DEVELOPMENT REVIEW BOARD
SUPPLEMENTAL SUBMITTAL

PROJECT NO. PR-2021-005459

SUBMITTAL DESCRIPTION: Response to DRB Comments Letter, Revised Site Plan and details addressing Transportation

**RE: PR-2021-005459 RESPONSE TO DRB COMMENTS
LOT 1A BLOCK 2 & LOT 2-A-1 BLOCK 2 SUNPORT PARK
2900 TRANSPORT ST NE**

DRAWING TITLE
BUILDING 400
FIRST LEVEL FLOOR PLAN

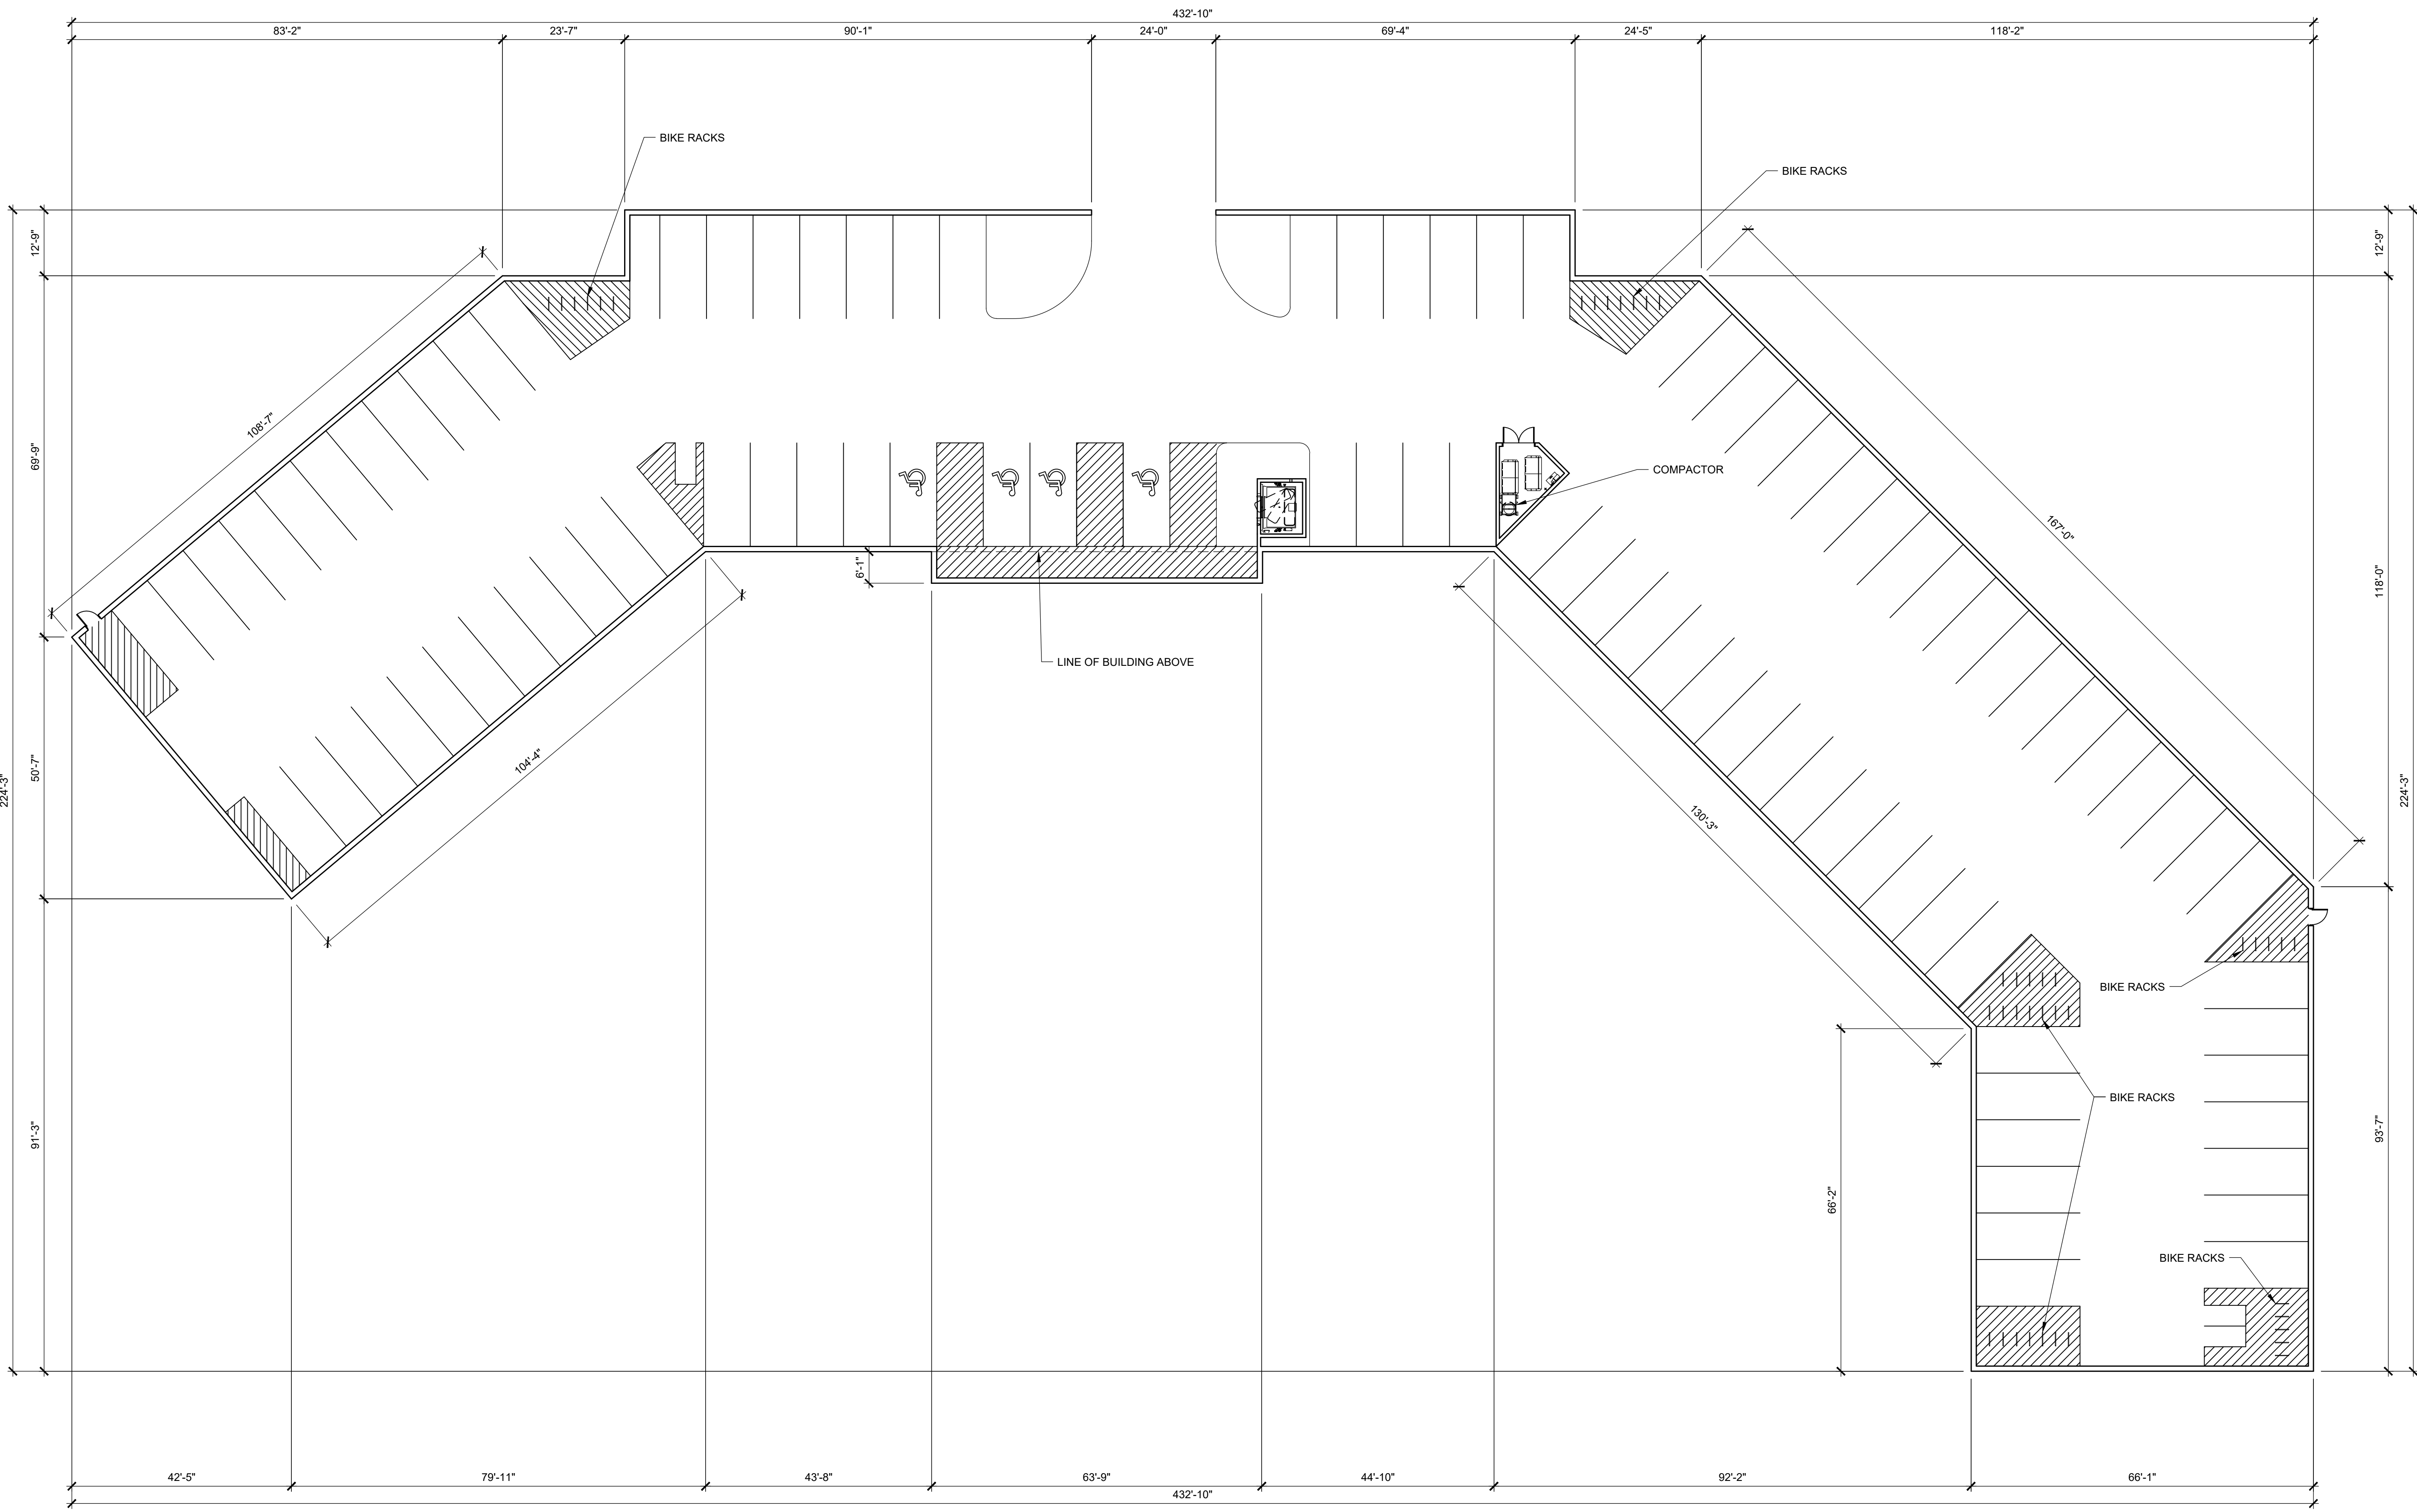
6. For the adjusted parking near the north accessway (parking beneath building), the accessway for handicapped spaces shown along the back appears to conflict with the infrastructure to the south and does not quite match recent discussions. On the overall site plan, make reference to detail sheet. (In order to make it fit, keep in mind that the minimum dimensions are 24-foot aisle, and 18-foot spaces.)

RESPONSE: HC pathway depicted in the basement floor plan of building 400. The parking level of building 400 is one story below the parking on the south side of building 400.

DRAWING TITLE
BUILDING 400 ELEVATIONS

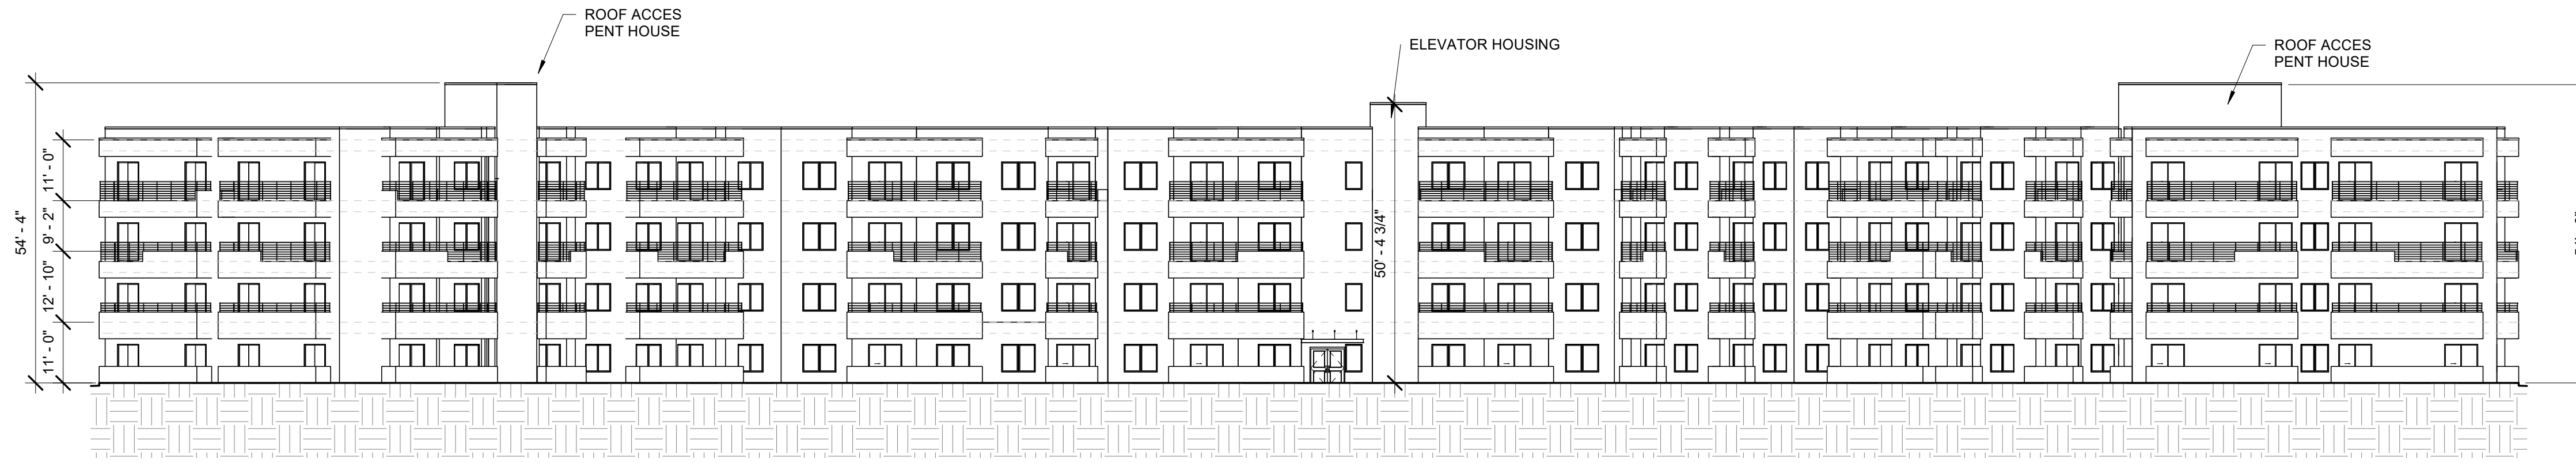
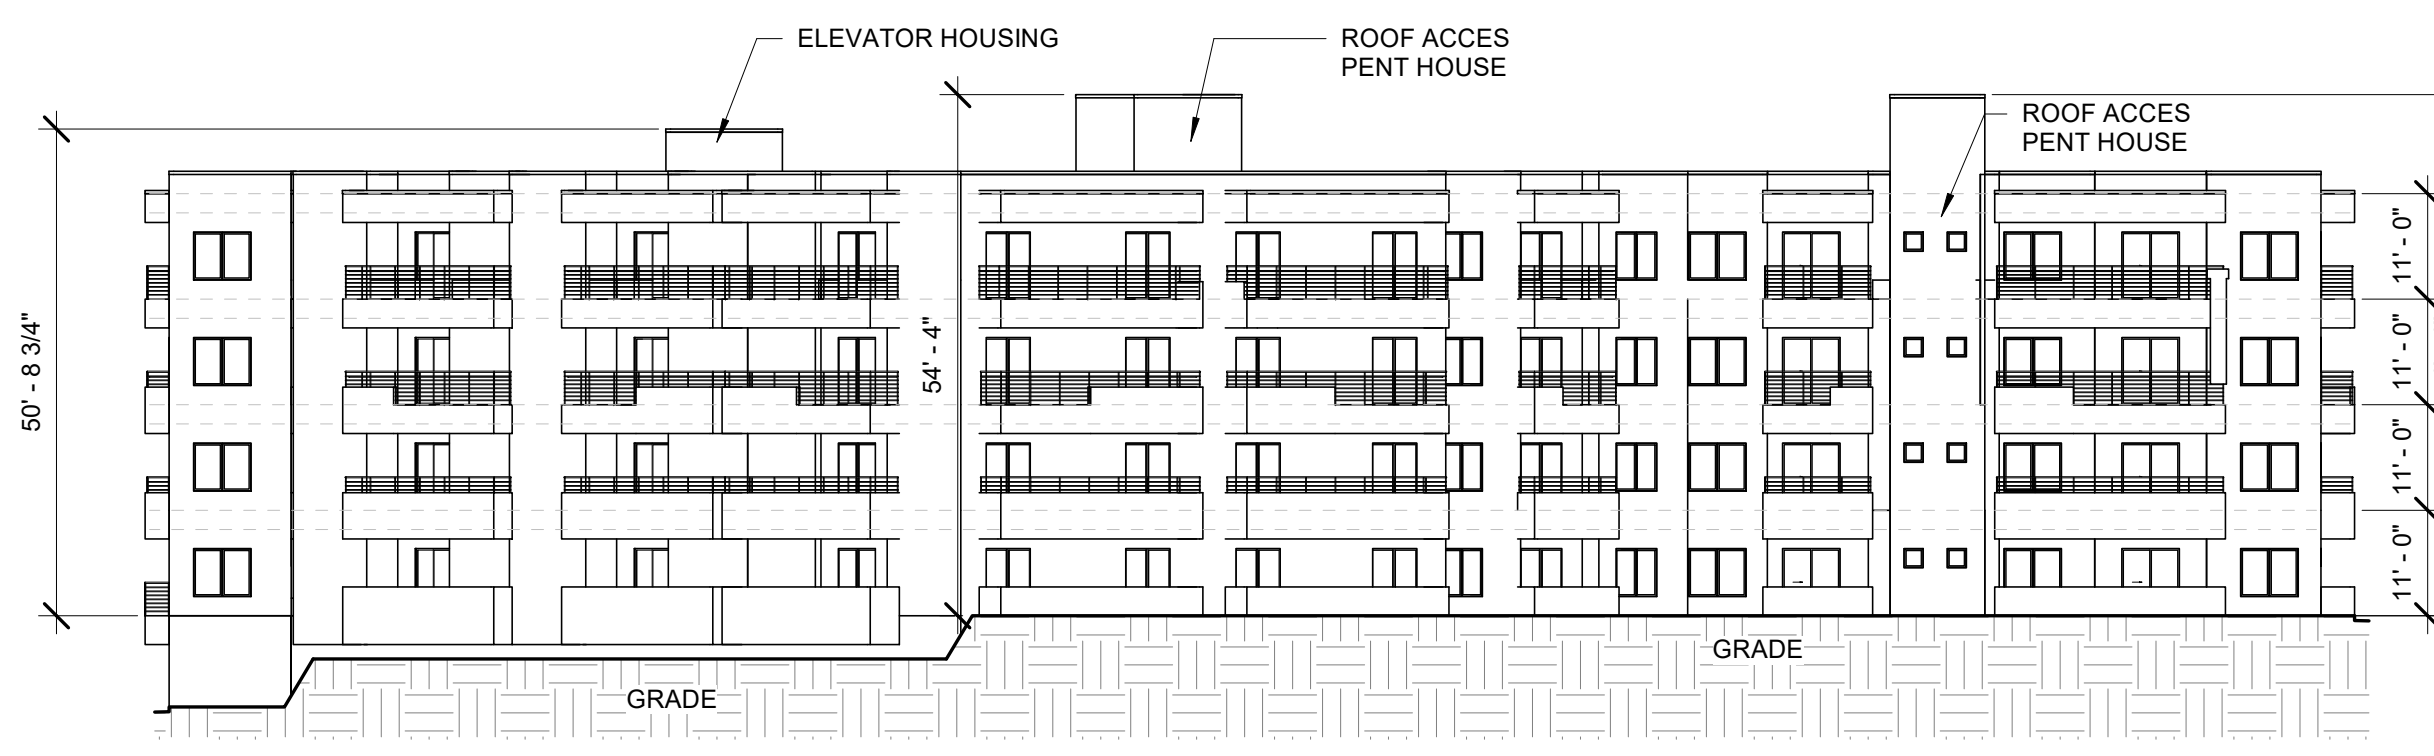
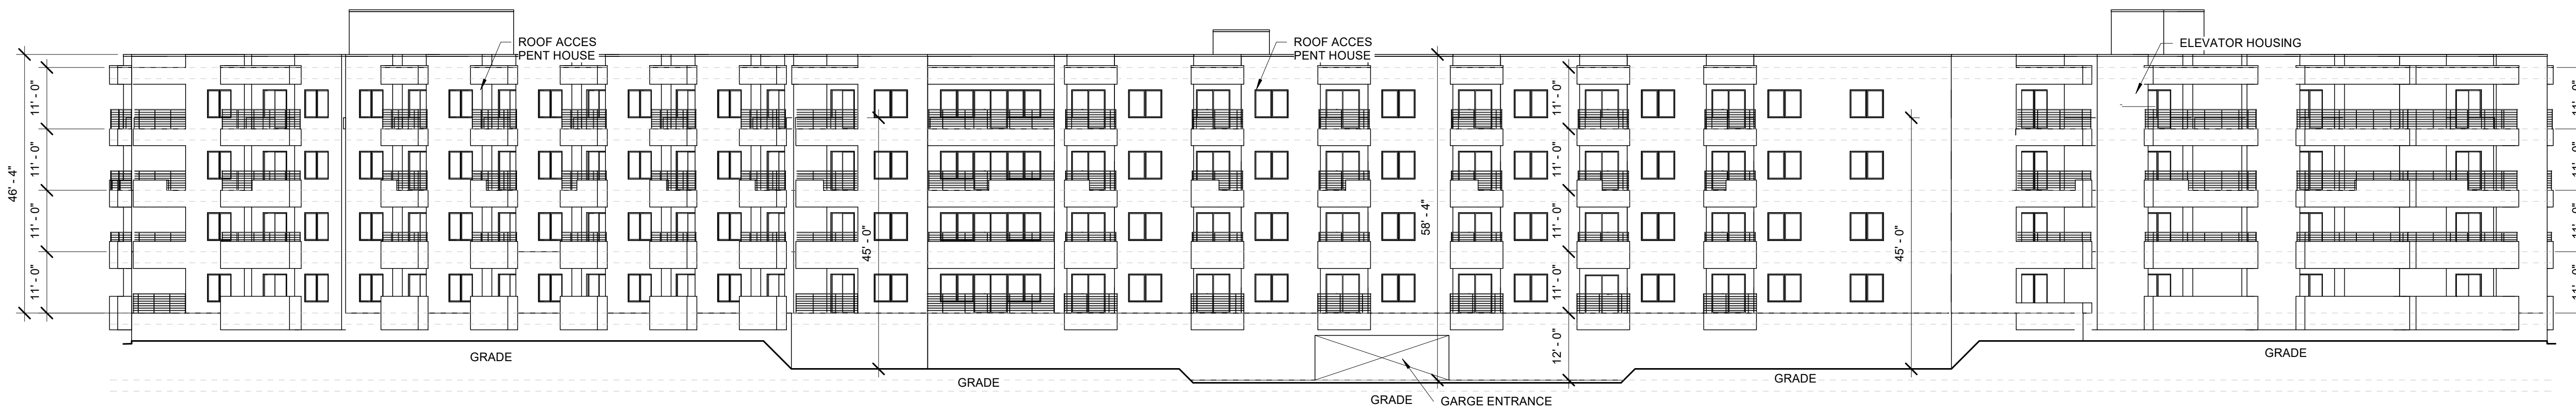
3. Please refer to the picture below regarding façade design suggestions.

RESPONSE: Reference the updated 3D images and the revised building elevations for building 400.
